802.1AXdz

YANG for Link Aggregation:

Editor's Report: November 2024
Version 1

802.1AXdz status

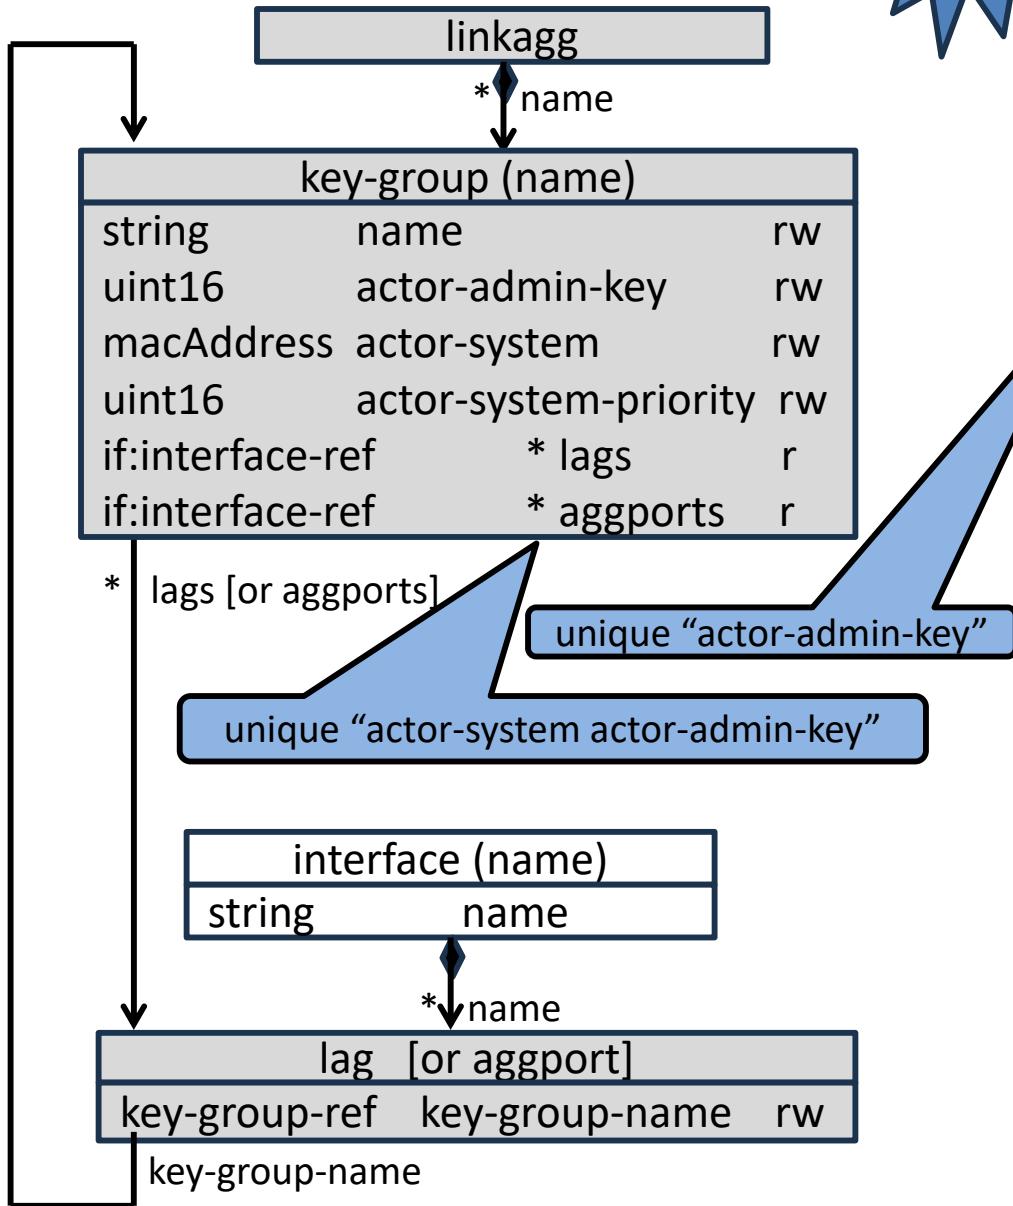
- Proposed Reject: 6, 8, 18
- Defaults: 12, 5, 9
- UML-like diagram: 1
- DRNI if-features: 3, 4
- System MAC address: 23

#23

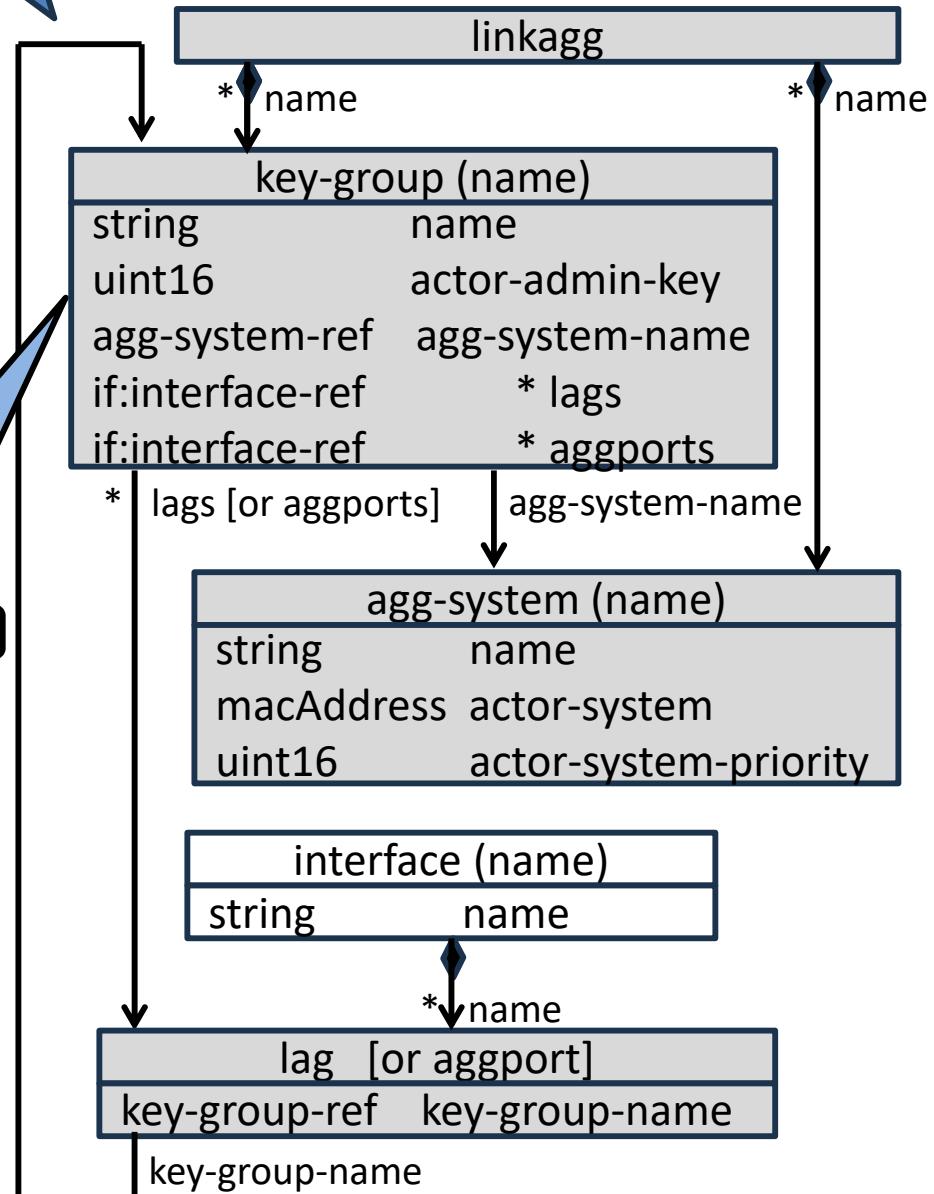
Proposed

#23

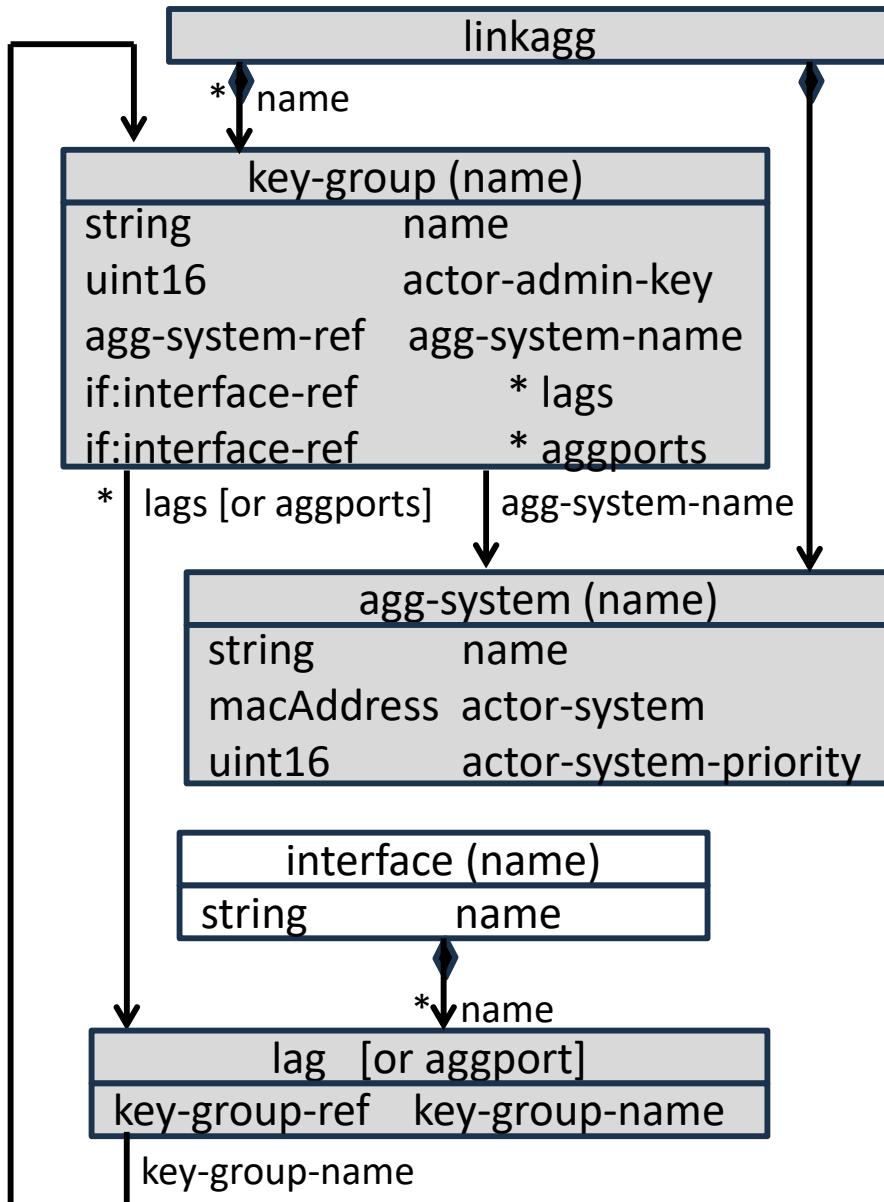
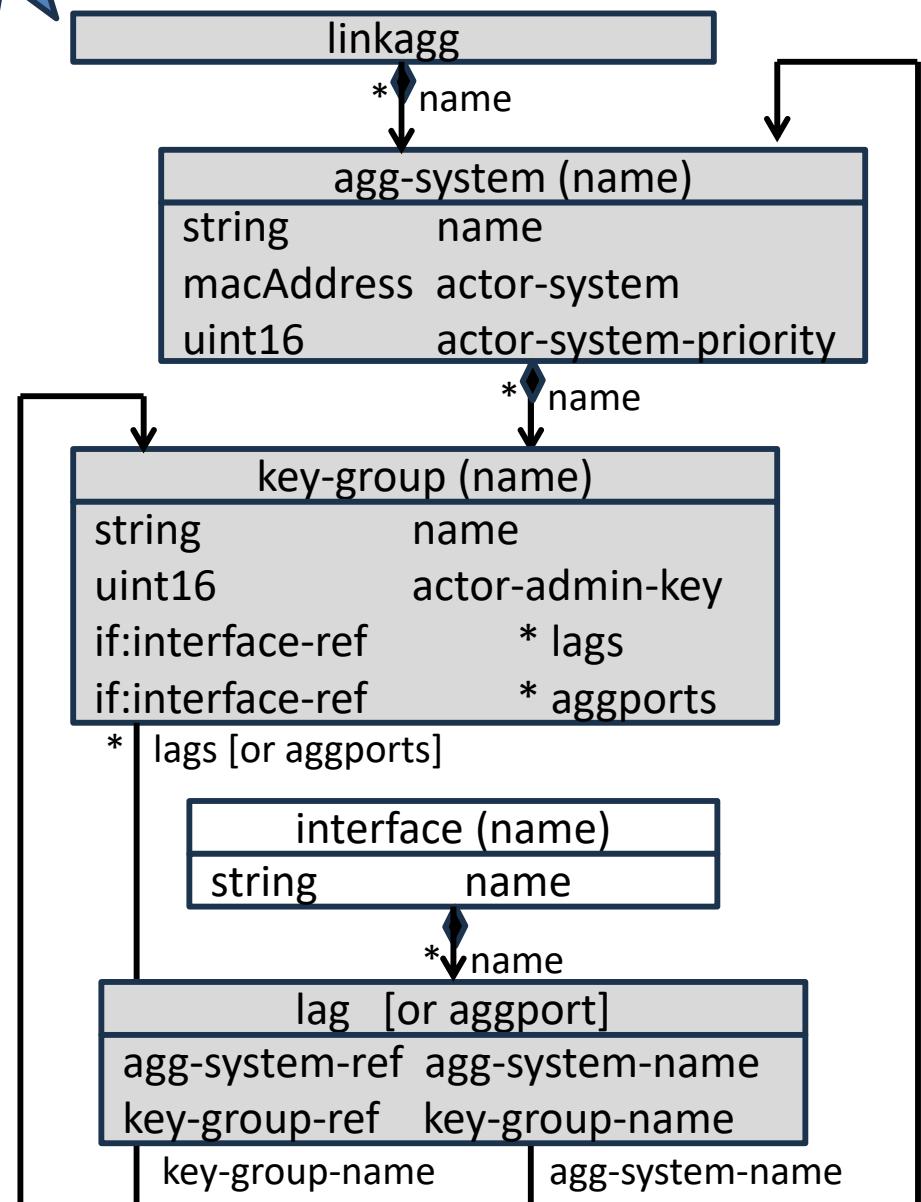
Proposed

Alternative
